CITY OF ALBUQUERQUE

**Re: Fraunhofer Solar Testing Facility
Grading and Drainage Plan
Engineer's Stamp dated 8-2-11 (R15/D001)**

GRADING & DRAINAGE PLAN

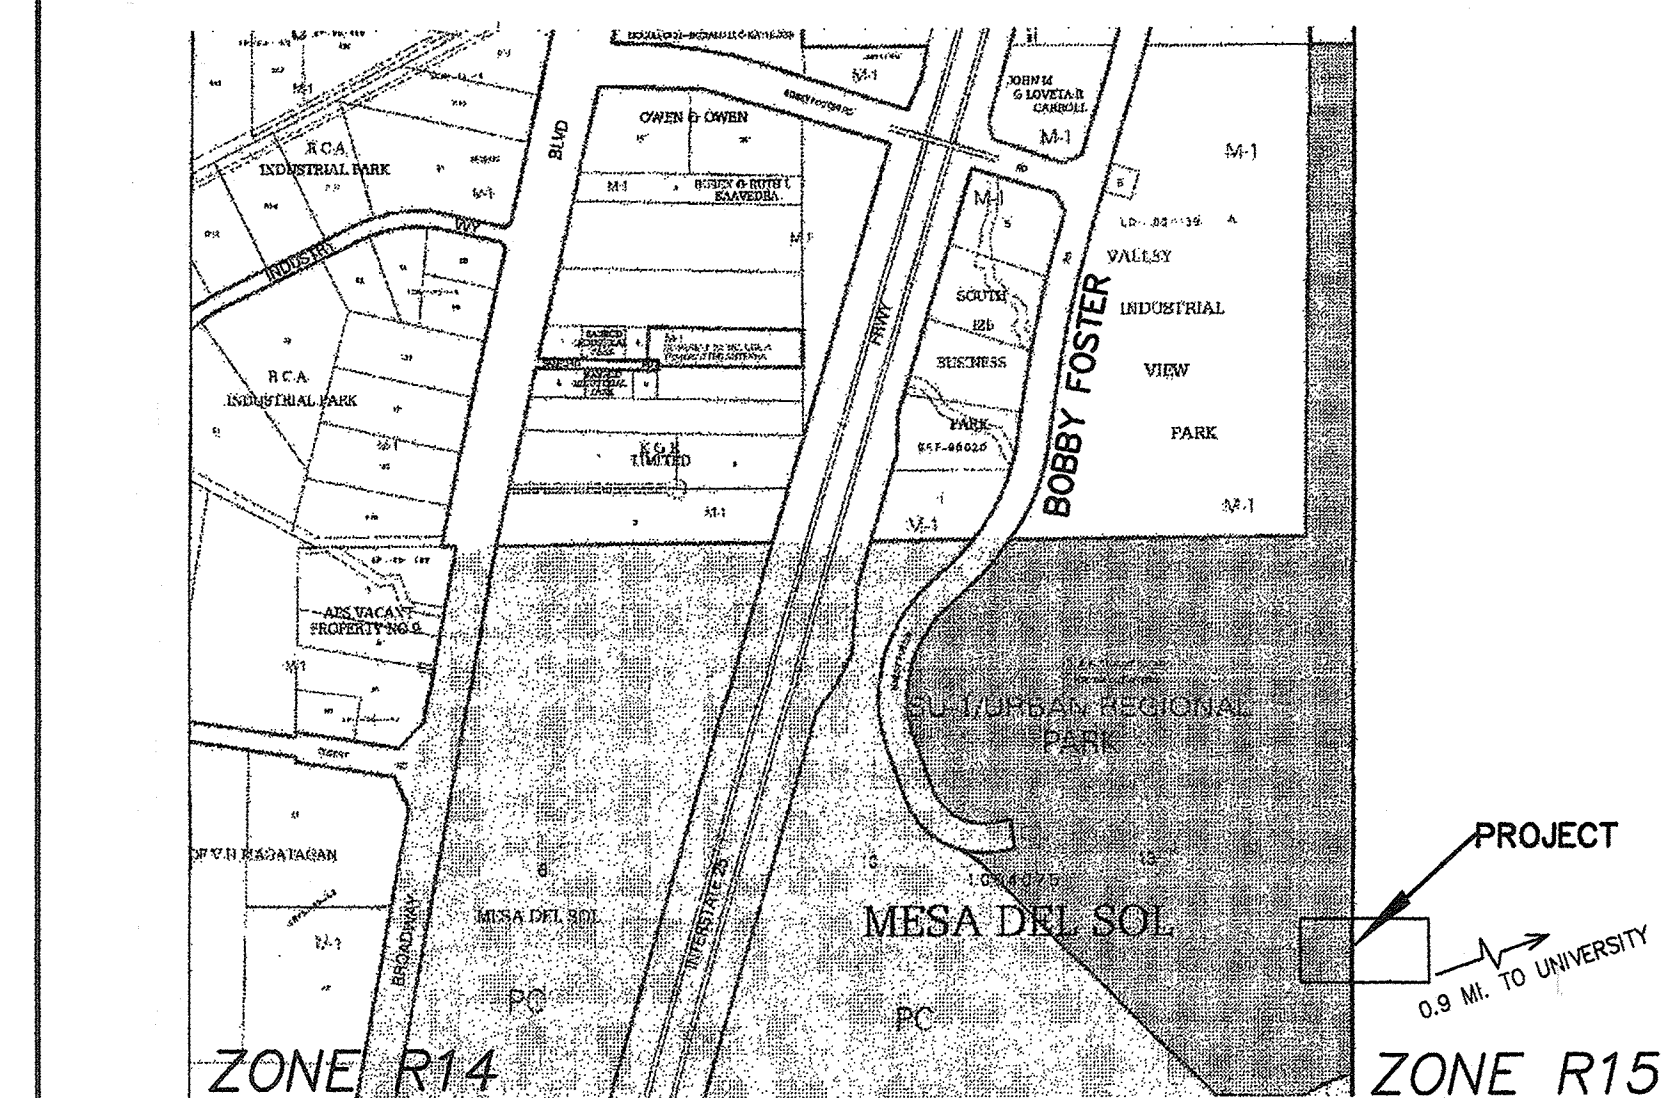
- Show the WSE, Volume Required, Volume Provided for each pond.
- Show the top of Berm at the NW corner pond at 5309 throughout.
- Show the FP for the portable building.
